Gonesse, le 18/12/2018.

INFO-TECH CITROËN Racing C3R5 18-04
Sujet : Etanchéité habitacle
Subject: Cockpit water proofness

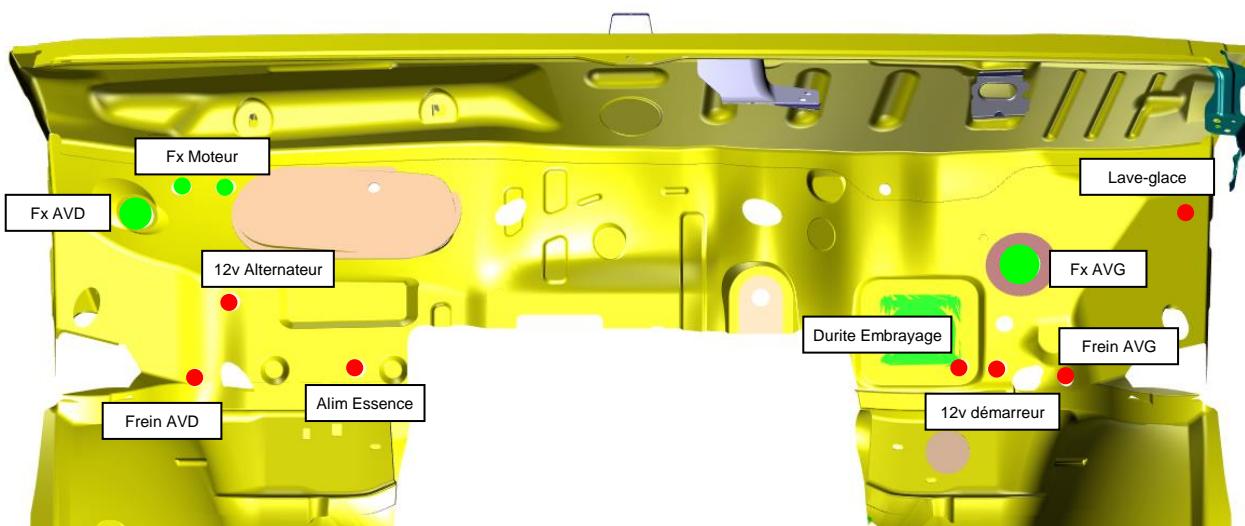
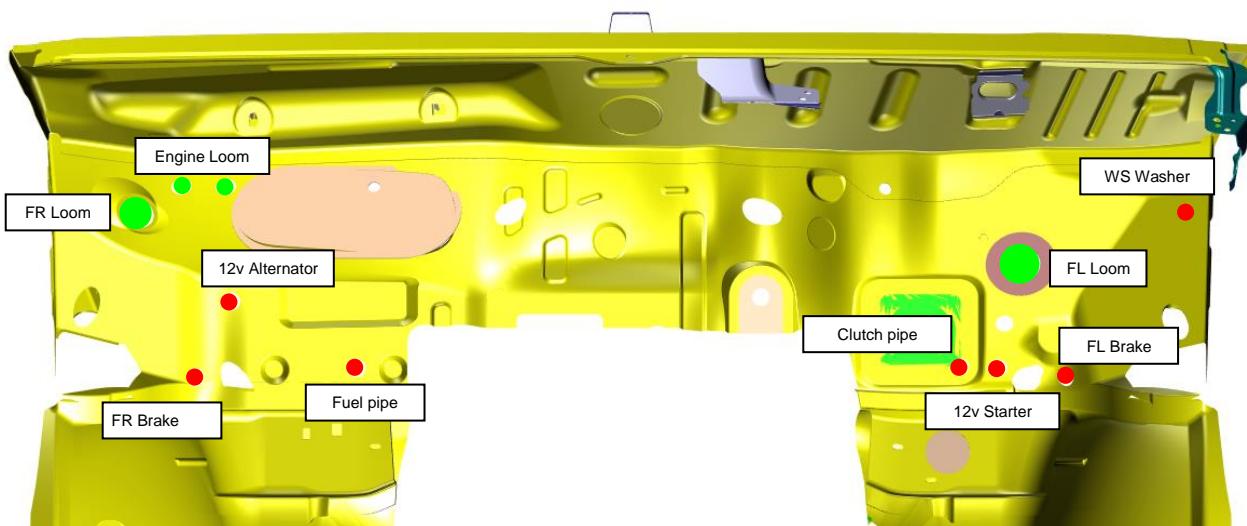
Afin d'éviter les entrées d'eau dans l'habitacle à travers le tablier (notamment côté droit en vis en vis de la powerbox), nous vous recommandons de renforcer l'étanchéité des différents passe-fils (en rouge) avec de la Caf ou Silicone.

De même, vous pouvez ajouter un joint de Caf ou silicone au niveau des passe-cloisons électriques (en vert)

To limit water ingress into the cockpit through the engine bulkhead (particularly at the right side close to the powerbox), we advise you to improve the proofness of all the grommets (red circle) with caf or silicone paste.

You can also improve the sealing of all the electrical grommets (in green) with caf or silicone paste.
